**TECHNICAL TIPS**

**Subject: SCU10, 12, and 13 Performance Labels**

**SUBJECT:** Service Valve Caps on Split System Product

**SUBJECT:** Sticking Service Valves on Split System Product

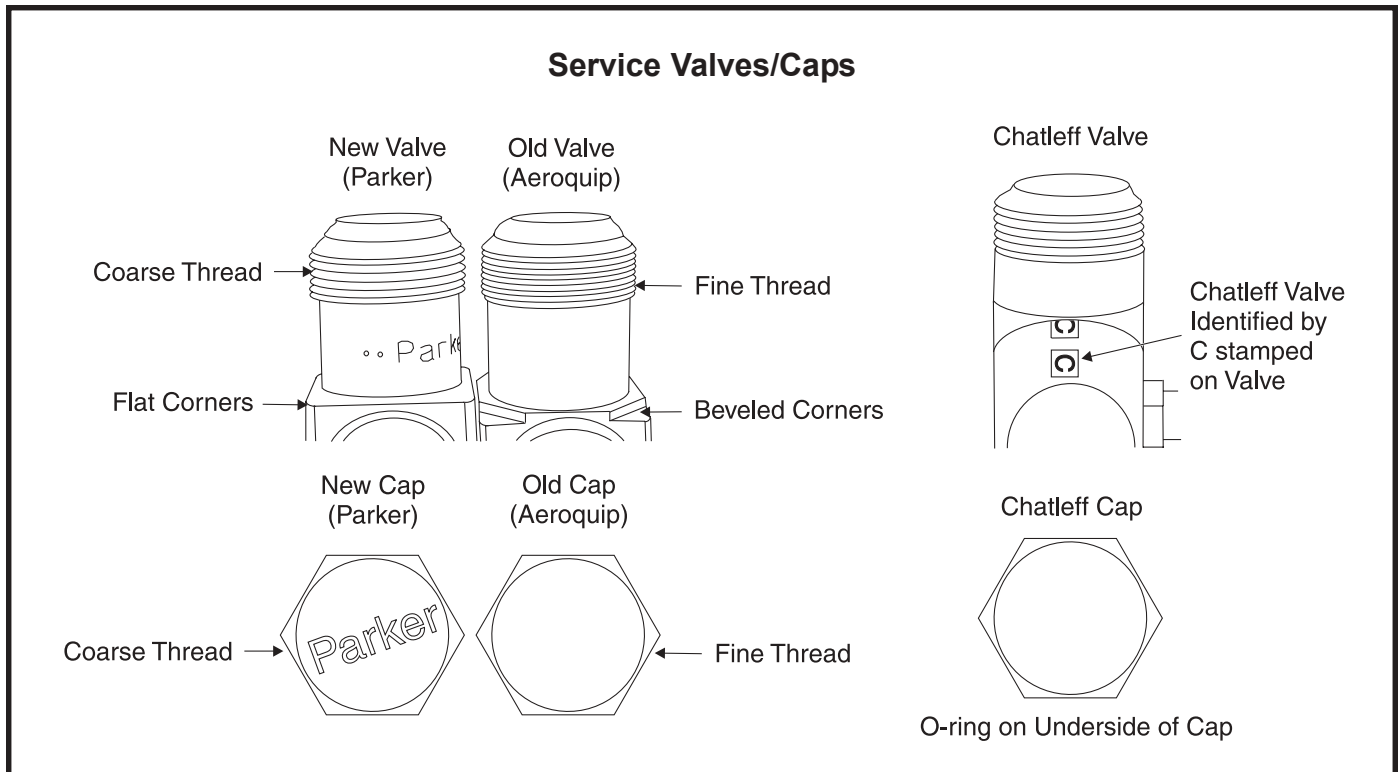
**DISCUSSION:** It has recently been determined that in some instances the caps of two valve suppliers (Aeroquip and Parker) may have become intermixed during production. A thread change was implemented on the caps of the service valves. A new coarse thread was used to standardize between the two valves. Product prior to the coarse thread introduction used a fine thread (see figure below). A third valve is also used, Chatleff, but it is not affected by this issue.

A fine thread cap will start on a coarse thread valve and a coarse thread cap will start on a fine thread valve. Although 1-2 turns may be achieved, they will not seat properly. Chatleff caps will only fit on the Chatleff valves, and Aeroquip and Parker caps will not fit Chatleff valves.

All valves now use the coarse thread cap and coarse thread valve. Suspect units have serial number dates codes 1602M, 1603A, 1603B, and 1603C. All inventory from 1603D and on have minimal, if any, occurrence.

**FIELD CORRECTIVE ACTION:** Replacement valve cap kits are available through Armstrong Technical Services. Kits contain 3/8", 3/4", and 7/8" coarse and fine thread caps. These kits will be provided on an "as needed" basis.

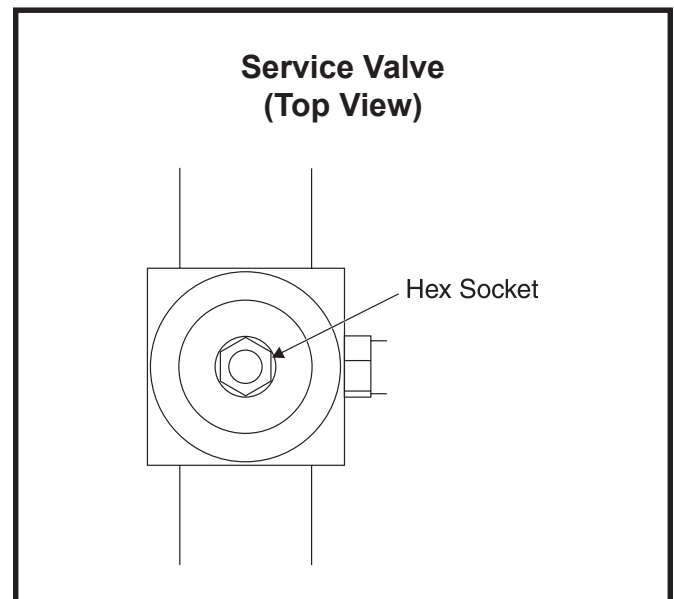
**DISCUSSION:** It has recently been determined that in some instances the service valves on the split system units may have been tightened beyond the specified settings. Generally it is the liquid line service valve (the smaller of the two) that is the more difficult valve to open. While occurrences have been low, we are providing a few valve opening guidelines in the event that a stuck valve should be encountered..

1. Make sure the hex wrench is completely inserted all the way to the bottom of the hex socket in the valve stem body (see figure below). Inserting the hex wrench only partially into the socket reduces the surface area that the wrench locks on to. The hex sockets in some of the sampled units were found to be slightly larger in the top 1/3 of the socket. Ensuring that the wrench is fully inserted and seated reduces the chances of the hex socket stripping while being opened.
2. Once the wrench is properly seated, use a backup wrench on the square valve body to secure the service valve while the hex socket is being turned.
3. If necessary, use a larger wrench on the hex wrench (such as an adjustable wrench, locking pliers, etc.) to gain more leverage when turning the hex wrench.

**FACTORY CORRECTIVE ACTION:** All inventory from 1603E and on are under strict calibration procedures. Liquid line valve (3/8") are torqued at 6-8 ft. lbs.; suction valves (3/4" and 7/8") are torqued at 18-20 ft. lbs.
